Re: EPD Comments
Voluntary Investigation and Remediation Plan and Application, November 30, 2011
Welcome Years, Inc., HSI Site No. 10637
Properties of VLP 2, LLC
1115 Howell Mill Rd, 673 Ethel St, 720 Fourteenth St, and "0" Fourteenth St
Atlanta, Fulton County, Georgia 30318
Tax Parcels: 17-0150-0009-064-9, 17-0150-0009-076-3, 17-0150-0009-062-3, and
17-0150-0009-061-5

The Georgia Environmental Protection Division (EPD) has reviewed the Voluntary Investigation and Remediation Plan (VIRP) dated November 30, 2011 submitted pursuant to the Voluntary Remediation Program Act (the Act). As part of the VIRP review, EPD also reviewed applicable sections of the February 14, 2011 Compliance Status Report and the April 15, 2011 Corrective Action Plan. EPD has the following comments:

Figure 1: Recommended Soil sampling locations for the 673 Ethel St. property

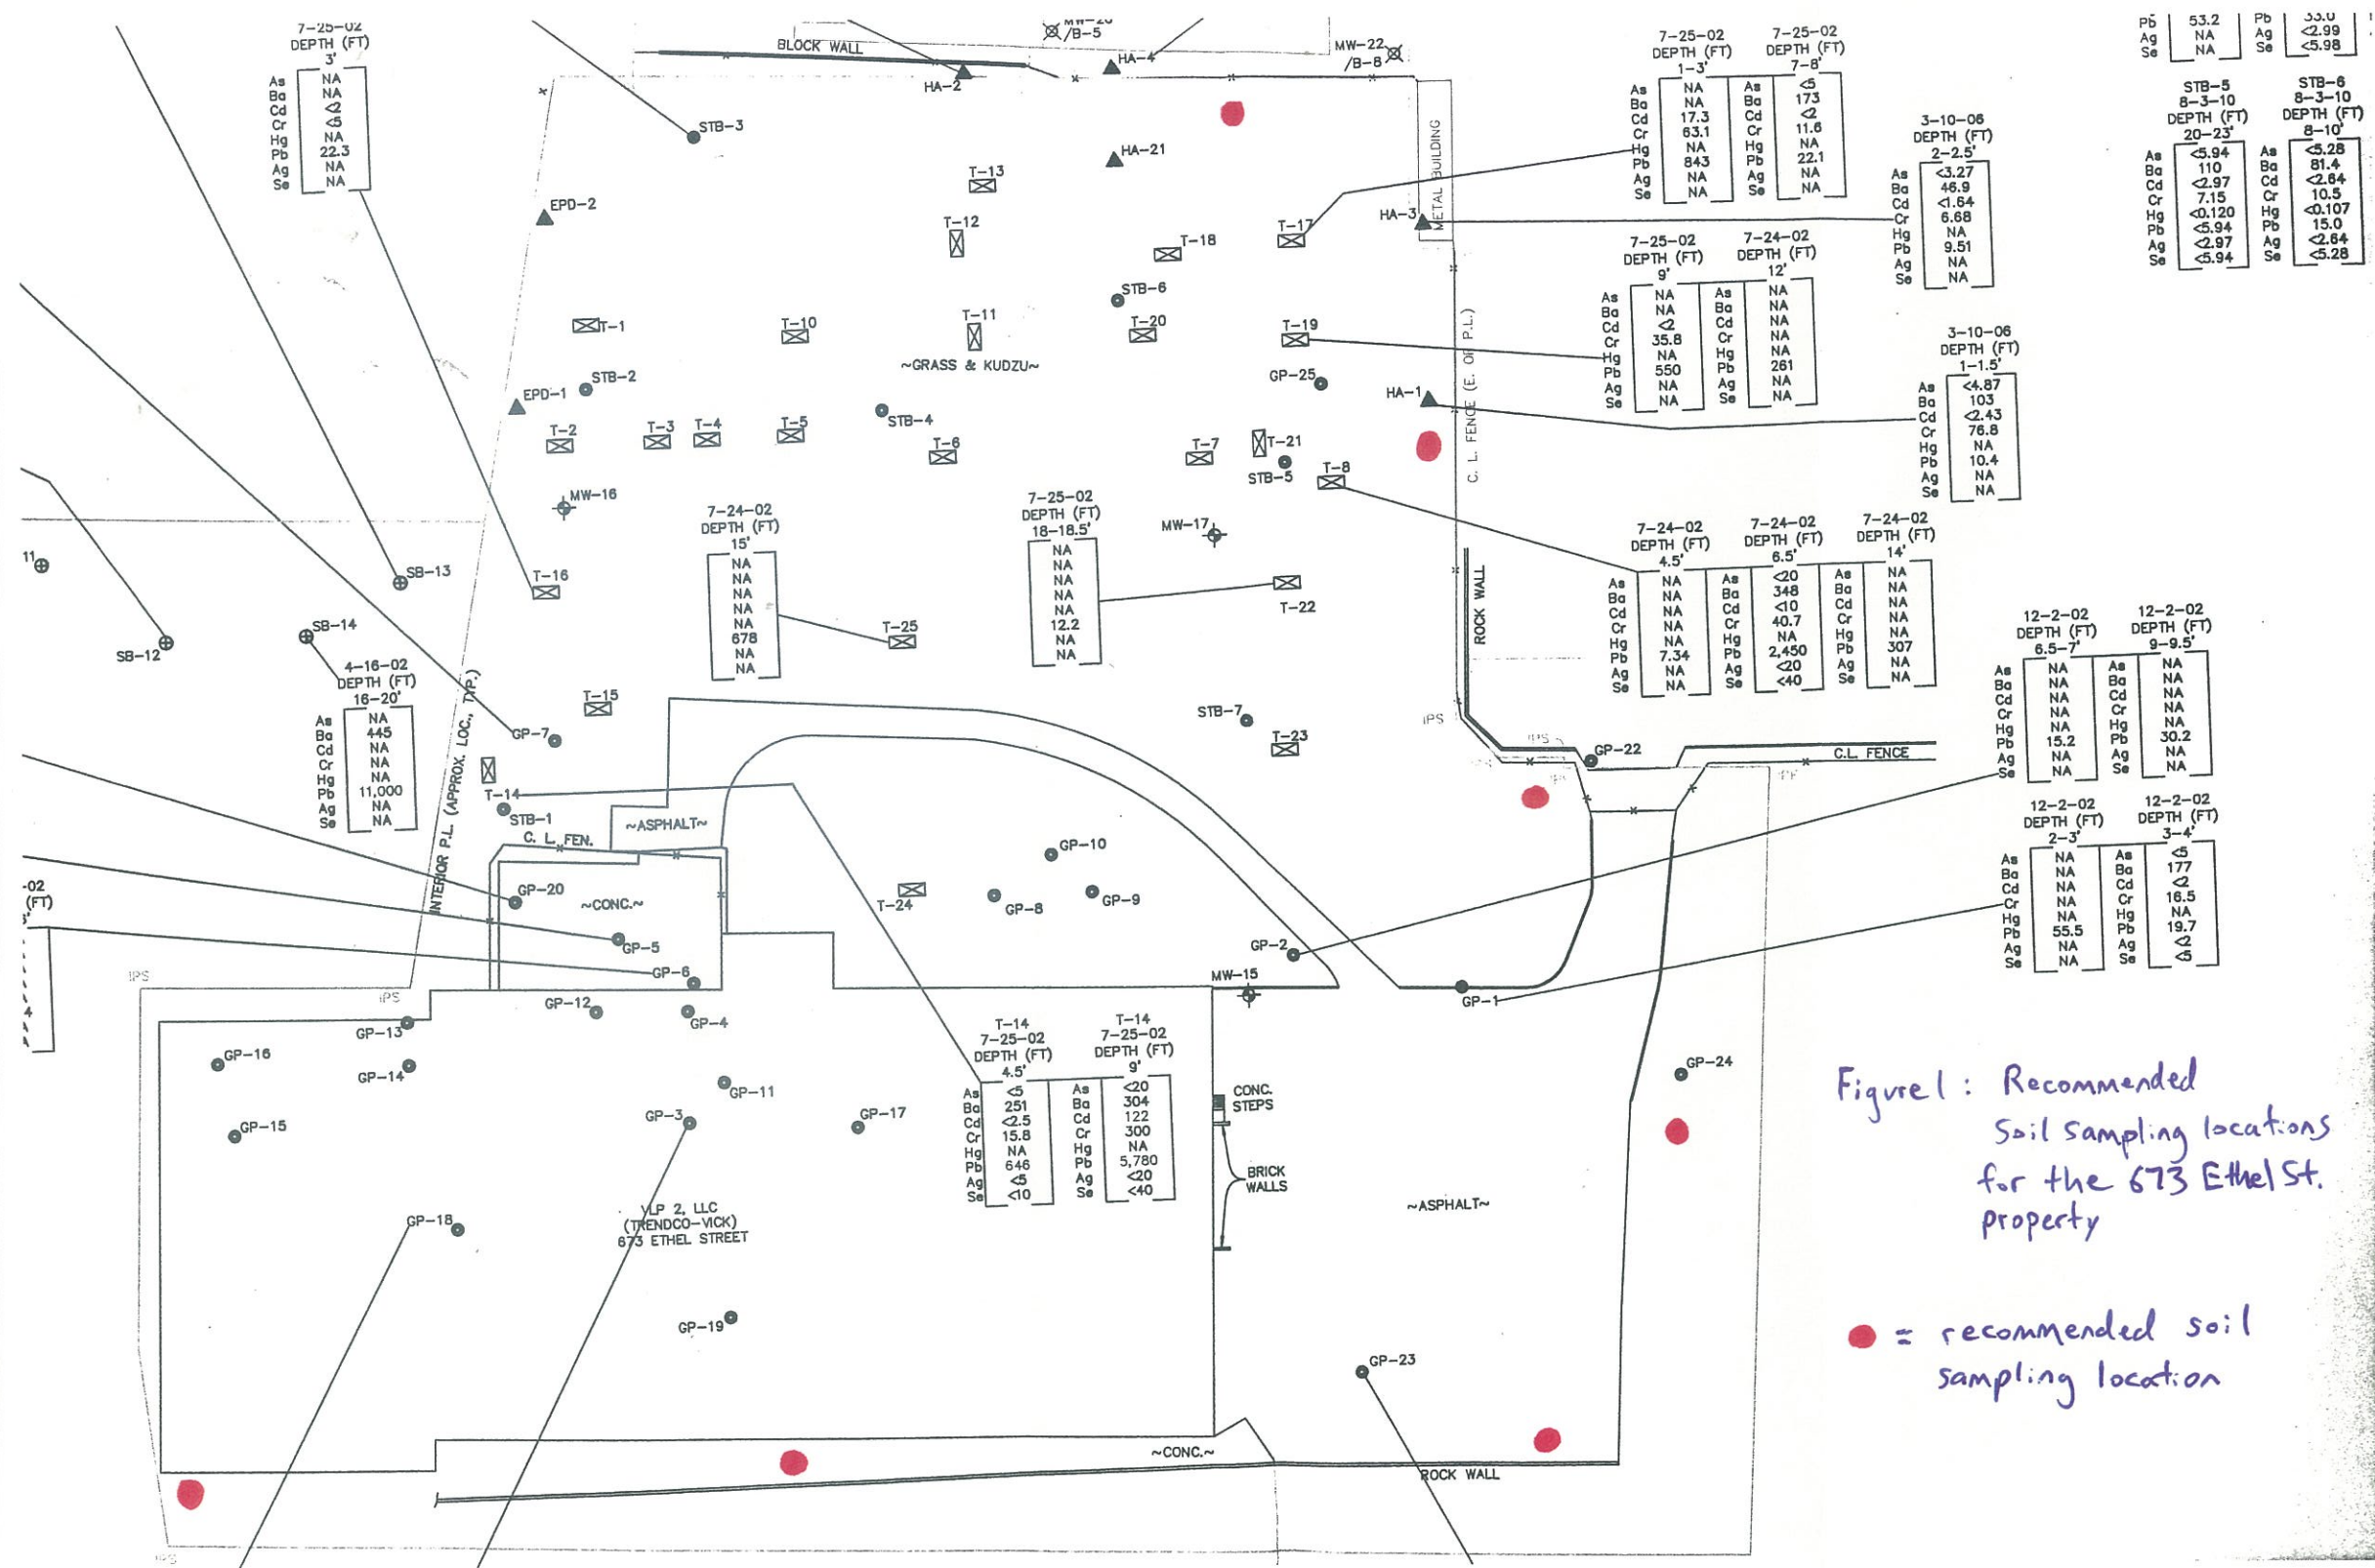
- b. Additional soil sampling is needed to show delineation of metals to Type 1 RRS. Recommended soil sampling locations for the 673 Ethel Street property are shown in Figure 1 (attached). Additionally, a soil sample should be collected at the northwest corner of the 1115 Howell Mill Road property, and soil samples should be collected from the 720 and “0” 14th Street properties. EPD recommends collecting soil samples at intervals of 0 – 6 inches, 18 – 24 inches, and every two feet thereafter until residual soil is reached. An XRF can be used to assist in analyzing soil for metals provided that a limited number of soil samples are analyzed using standard laboratory methods to verify the XRF results.
